AGENDA
Regular Hybrid Meeting
Town of Granby
Inland Wetlands and Watercourses Commission
Wednesday, July 9, 2025, at 7:00 pm
Town Hall Meeting Room

This letter is being submitted by Kimley-Horn & Associates, Inc. on behalf of AutoZone, Inc. ("Applicant") in response to the department review letters listed below:

AUTOZONE GRANBY

8 E GRANBY ROAD
GRANBY, CT 06035

SHEET NUMBER
C-5.0

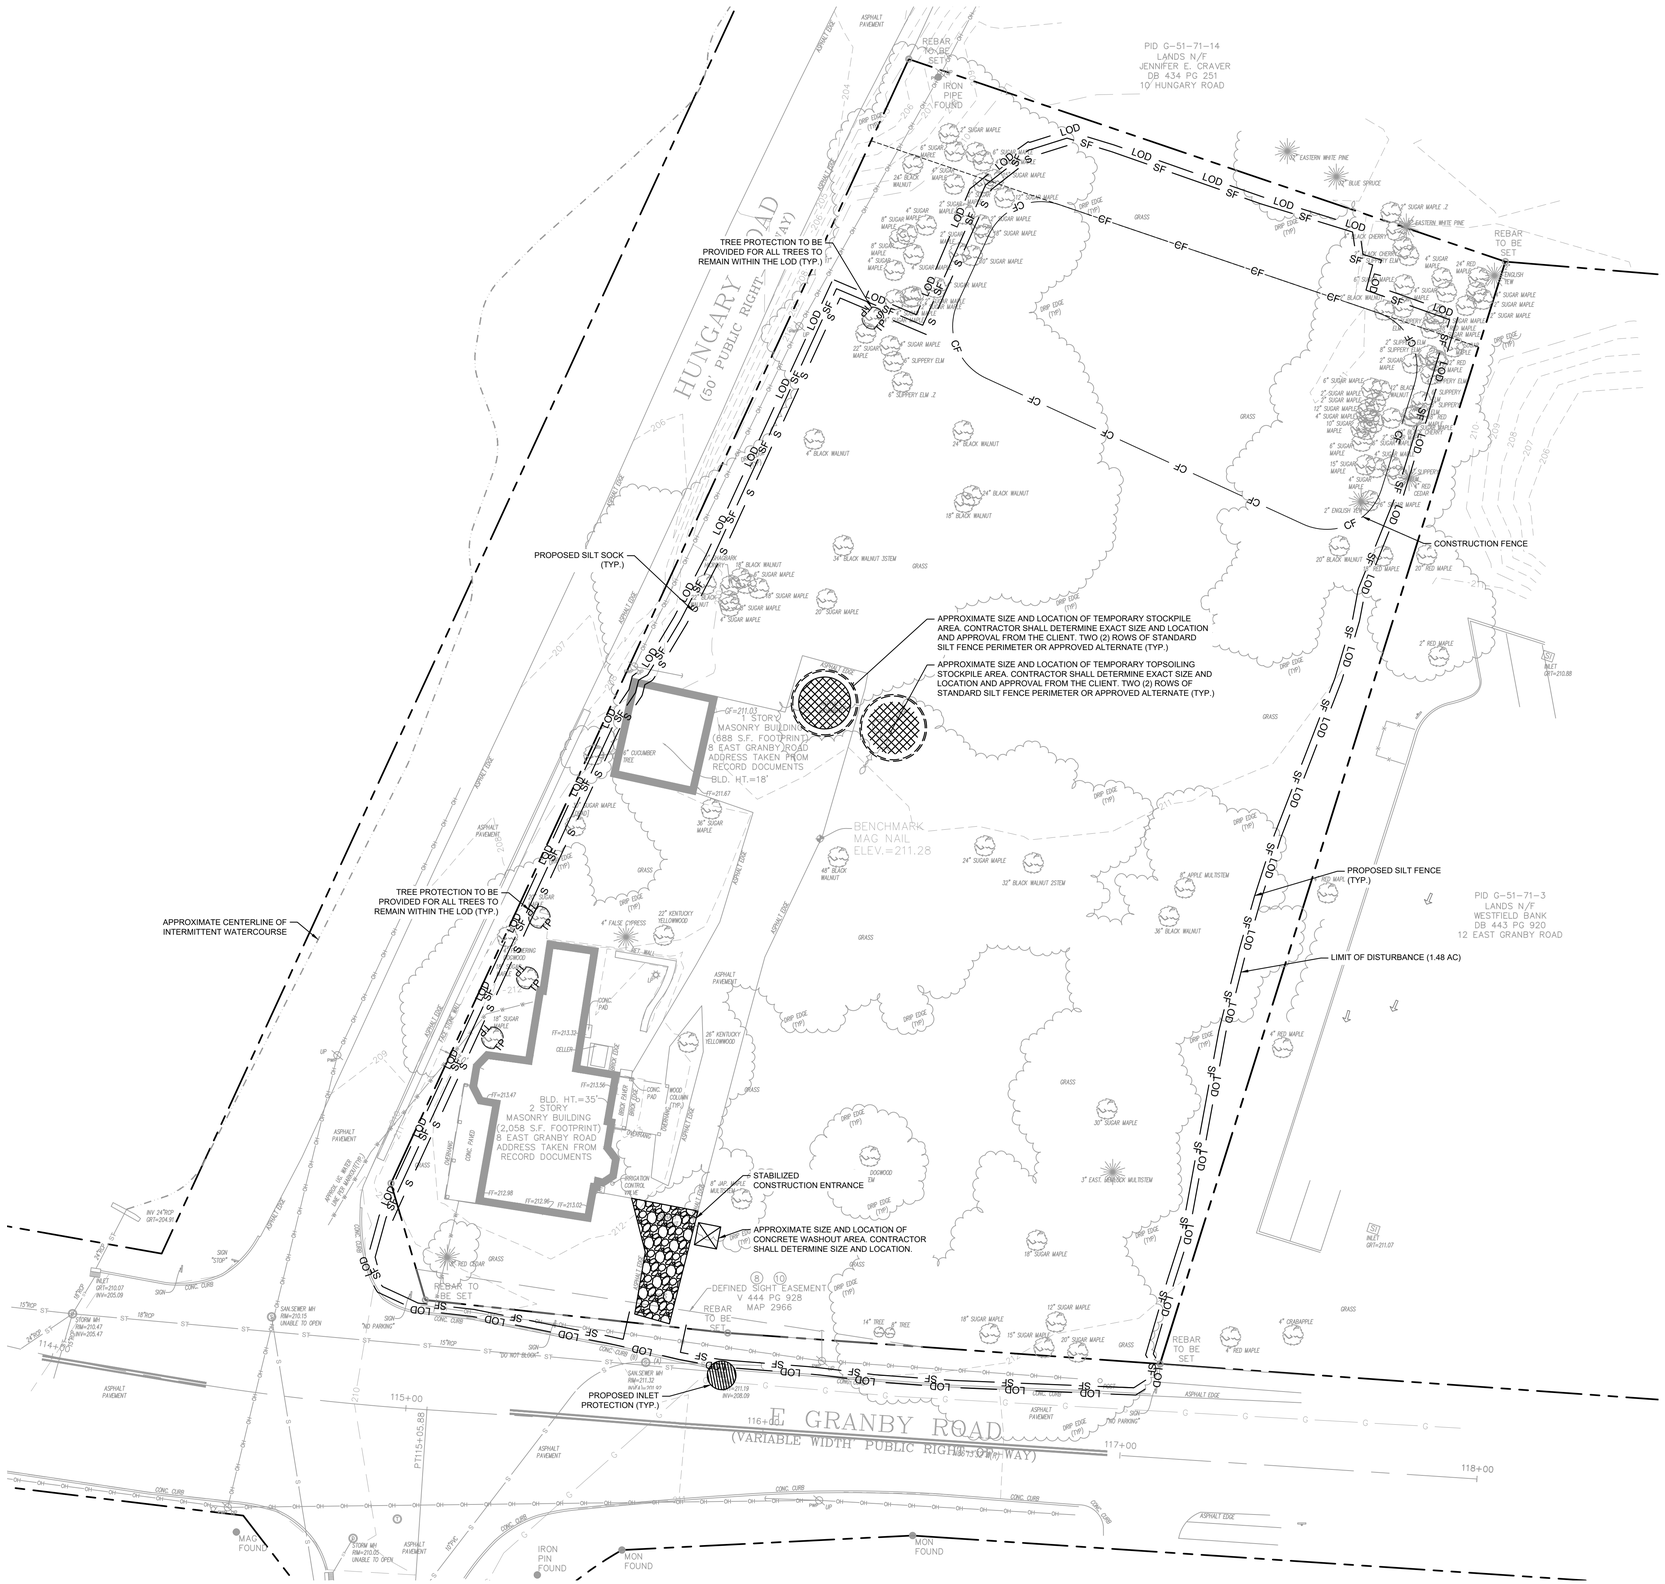
8. Show tree protection where its required.

10. Show proposed stabilization for the basin (e.g. seeding, ECM). Show protection of the basin during construction.

3. Sheet C-5.0 shows silt fence to be specified as a perimeter erosion control barrier enclosing the entire disturbance area. It is recommended that a more robust perimeter control be located along the westerly property boundary, to aid in protecting the adjacent watercourse, where there is a slope adjacent to Hungary Road.

Response: Sheet C-5.0 has been revised to show tree protection where required.

Response: Sheet C-5.0 and C-5.1 have been revised to show the proposed stabilization and protection of the infiltration basin.

Response: Sheets C-5.0 and C-5.1 have been revised to include an additional row of silt sock before the silt fence on the western property boundary per discussion with Kate Bednaz on 6/5/2025.

SHEET NUMBER
C-5.1

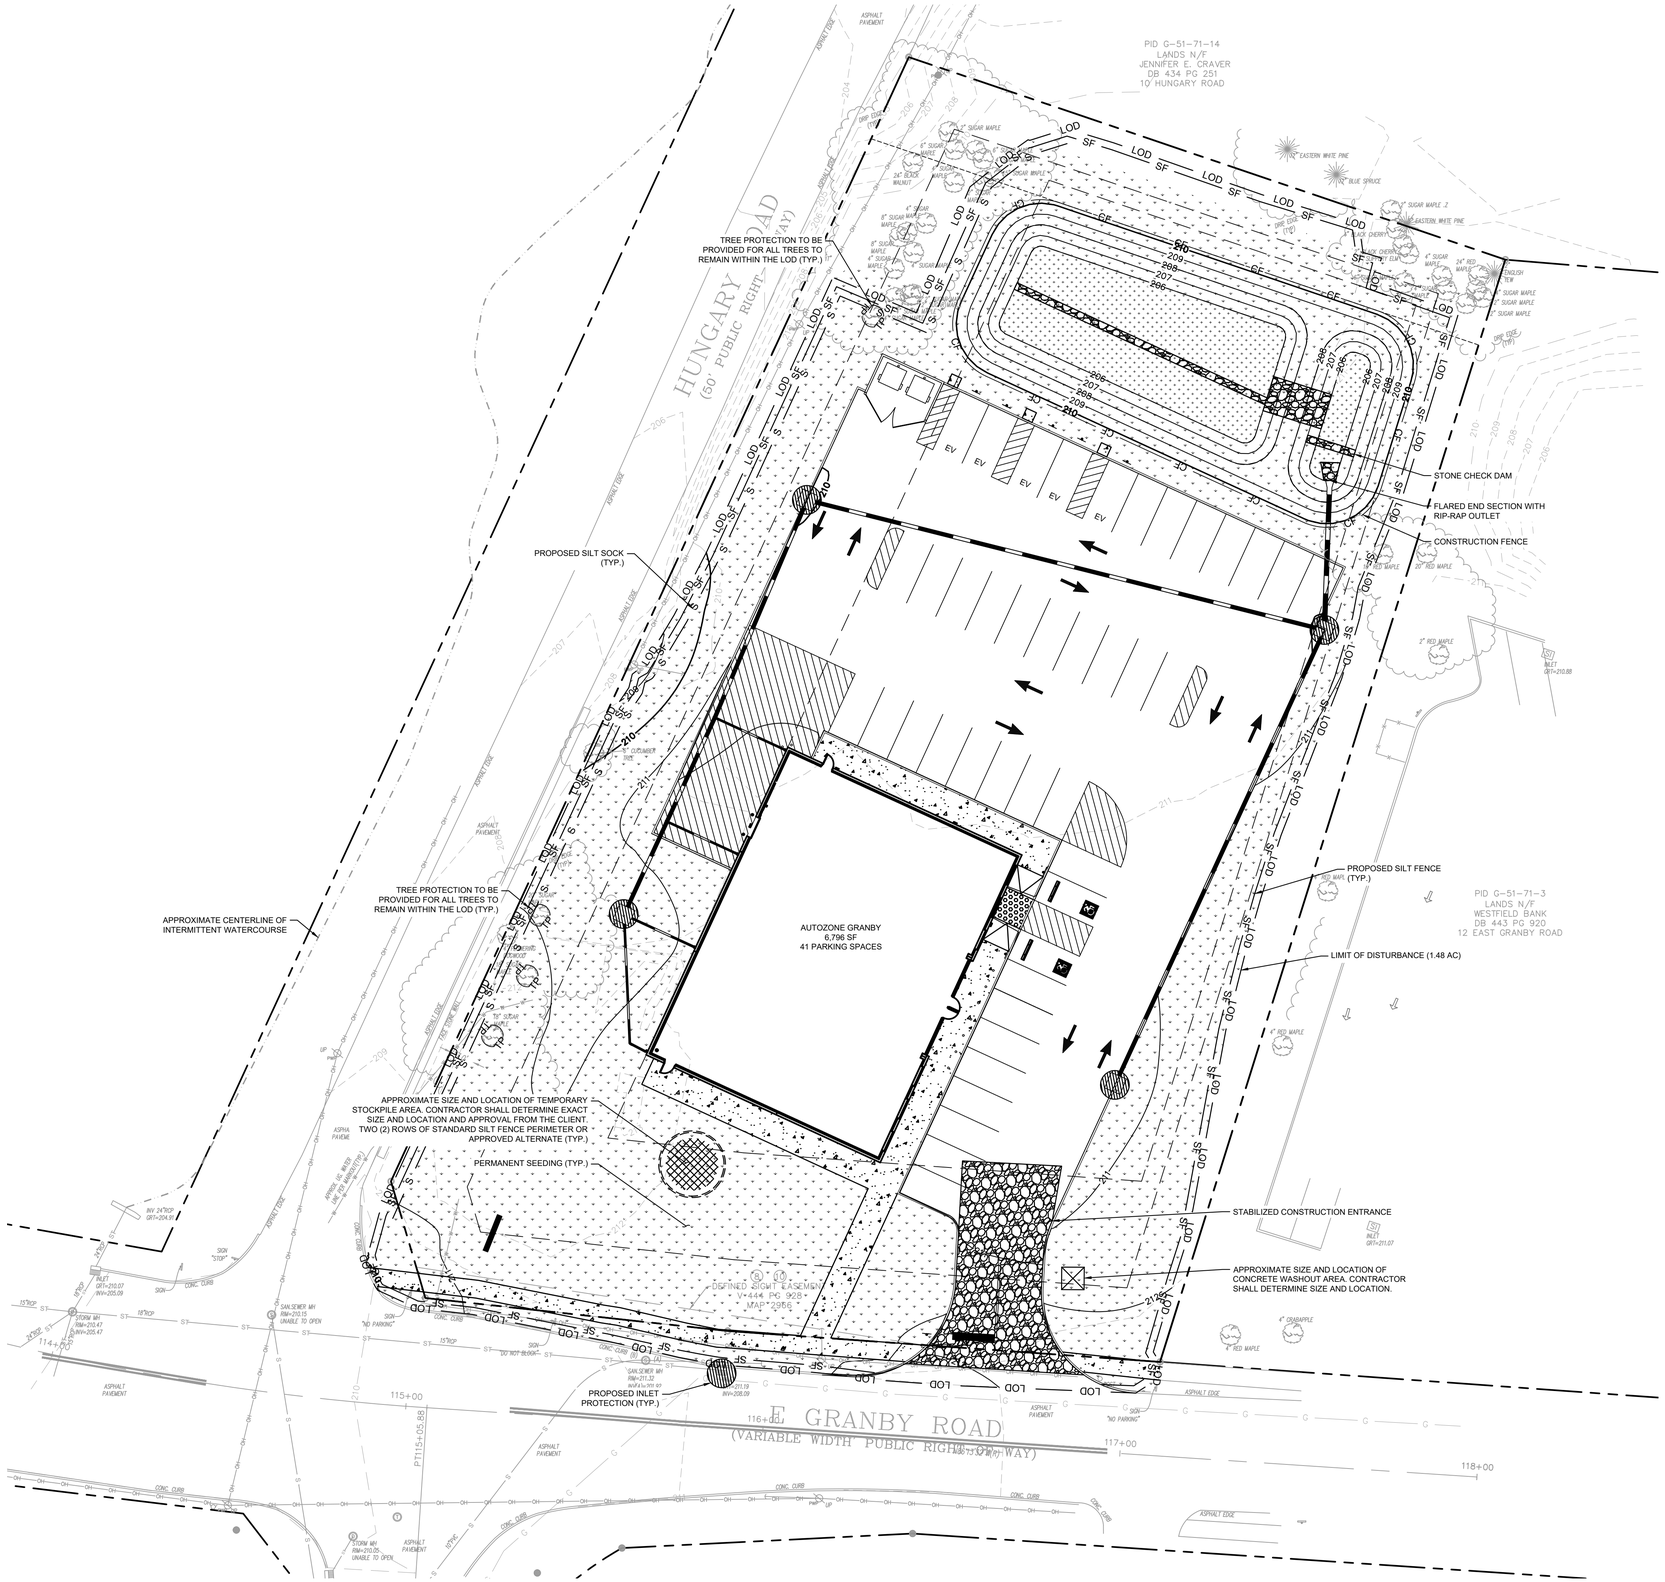
9. Show outlet protection for pipes that will discharge into the infiltration basin. Include stone check dams to protect the area outside of the outlet protection. This will limit the spread of sediment in the forebay.

13. Add callouts for location of all erosion and sediment control features. (e.g. topsoiling, temporary and permanent seeding, tree protection, etc.) Put the specifications for these items on sheet 5.2.

Response: Sheet 3.0 and Sheet C-5.1 have been revised to show a flared end section with associated rip-rap and stone check dam to meet out

Response: Sheets C-5.0 and C-5.1 have been revised to include callouts for locations of all erosion and sediment control features. Sheet C-5.3 (previously C-5.2) has been revised to include specifications for each item.

SHEET NUMBER
C-5.2

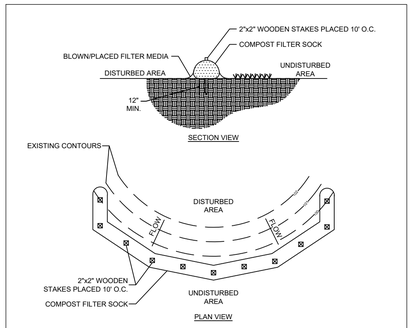
14. Add a detail for a compost filter sock.

Response: Sheet C-5.2 has been revised to include a detail for a compost filter sock.

SHEET NUMBER
L-1.0

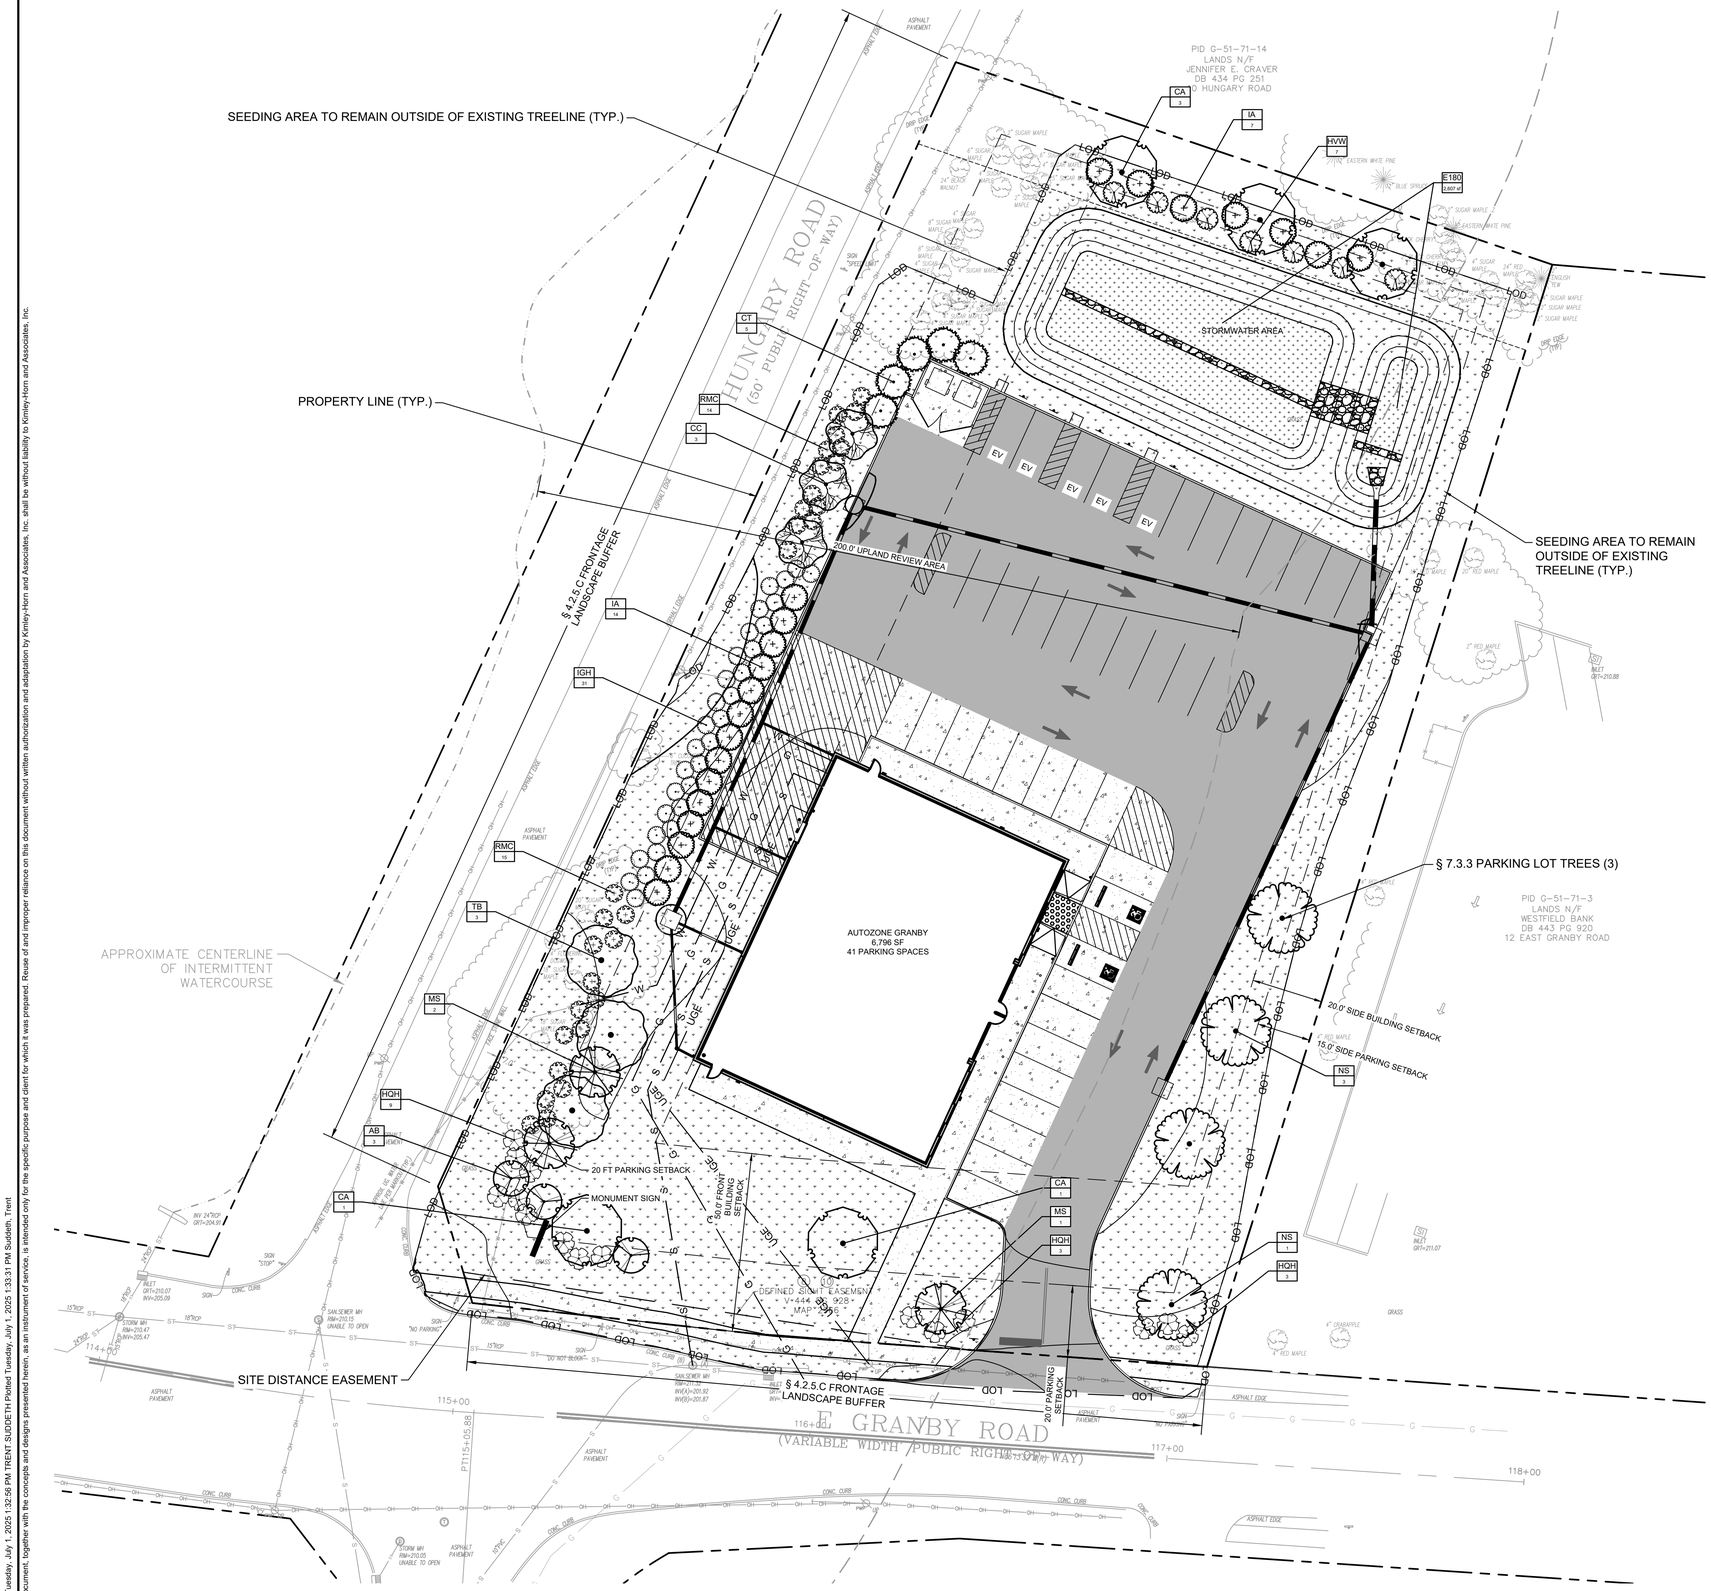
2. I do not see a landscape plan. Typically IWWC will want to see this as part of the application, specifically plantings within the URA.

Response: A landscape plan and notes have been added to the planset as Sheets L-1.0 & L-1.1.

Response: A 25-foot landscape buffer is provided at the north of the property. The extents of the infiltration basin have been revised to be outside the 25-foot buffer. Landscaping has been added and is shown on Sheet L-1.0.
